Nevada Division of Environmental Protection-Bureau of Air Quality Planning (NDEP-BAQP) BART Determination Review of Nevada Energy's Reid Gardner Generating Station Units 1, 2 and 3

A BART analysis was completed by CH2M HILL at the request of Nevada Energy (NVE) for Units 1, 2 and 3 at the Reid Gardner Generating Station (Reid Gardner) dated October 3, 2008. Reid Gardner consists of three BART-eligible units with a generating capacity of 110 megawatts (MW) each. A fourth unit (265 MW) is not BART-eligible. The units are wall-fired boilers which burn primarily bituminous coal. NVE's BART analysis is summarized below organized according to the five step analysis contained in Appendix Y of 40 CFR 51 of control options for sources subject to BART.

FIGURE 1
LEAST COST ENVELOPE

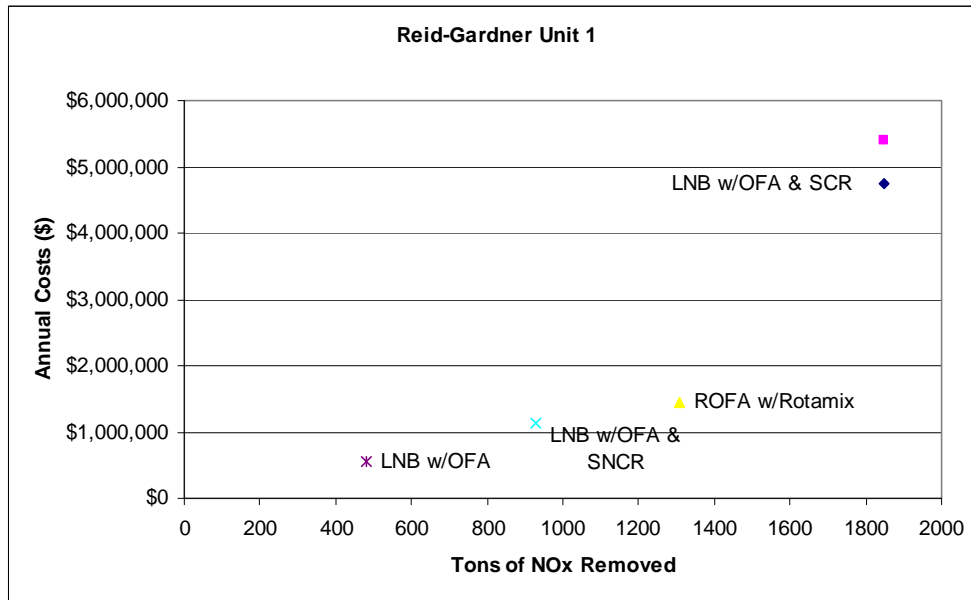
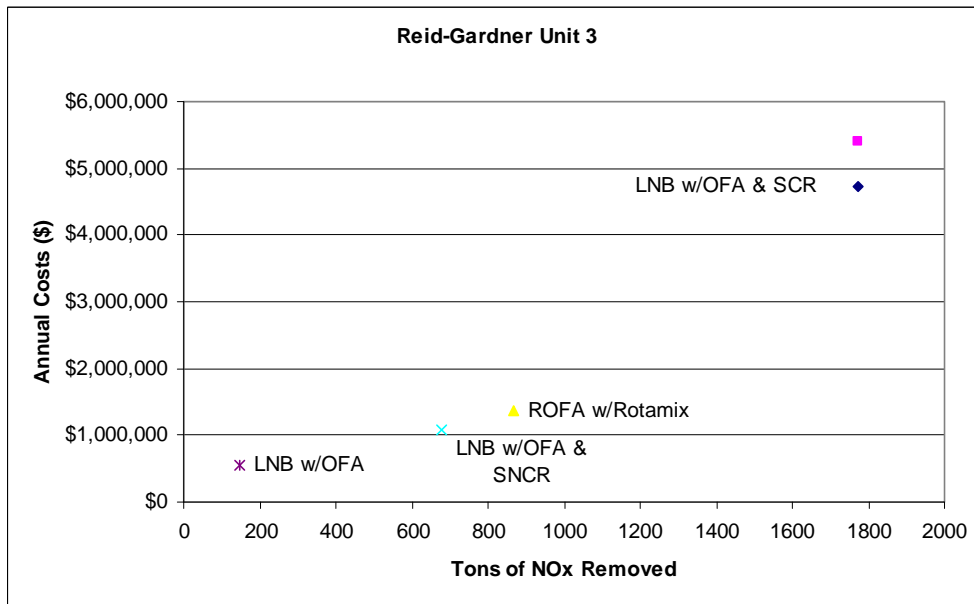
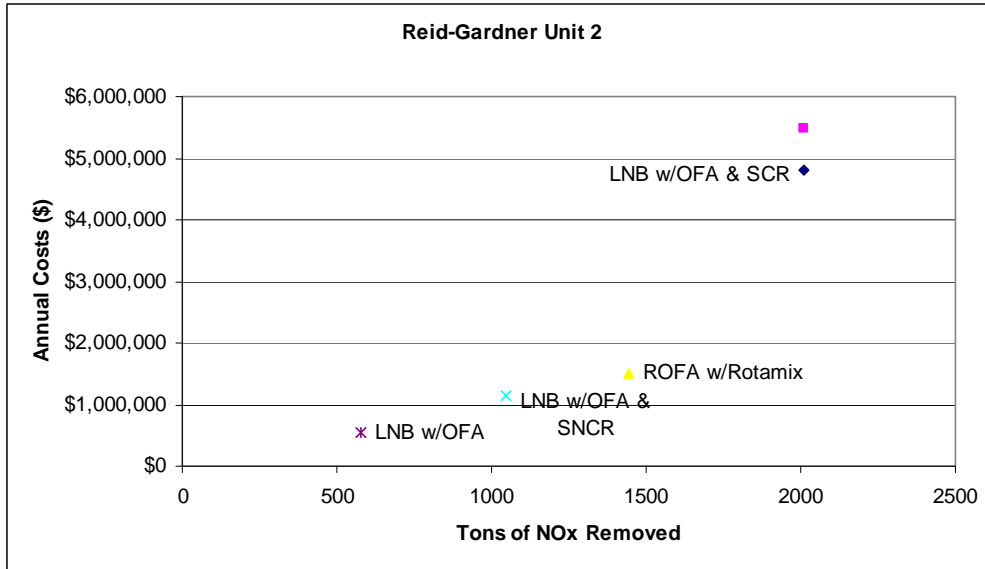
NDEP specifically reviewed the cost per ton of NO_x removed for each unit at Reid Gardner and determined that installation of ROFA with Rotamix for Units 1 through 3 meets the BART criteria, with associated costs of \$1,038 to \$1,588/ton of NO_x removed, depending on the unit evaluated. These values are considered cost effective. The cost data from the tables above are presented graphically in Figure 1. NDEP also concluded based on a review of the economic analysis that the \$/ton of NO_x removed increased significantly for LNB with OFA and SNCR technology without any clear environmental benefit.

Visibility improvement upon installation of ROFA with Rotamix is anticipated to be greater than modeling with NVE's proposed BART limit. Modeling the visibility impact based upon the emission rates presented in Table 1 will be performed at a later date. Thereafter, data will be added to this report. Based on this review, NDEP concludes that for NO_x the installation of ROFA with Rotamix with an emission level at 0.20 lb/MMBtu for Unit 1 and Unit 2, and 0.28 lb/MMBtu for Unit 3, on a 12-month rolling average, is BART.
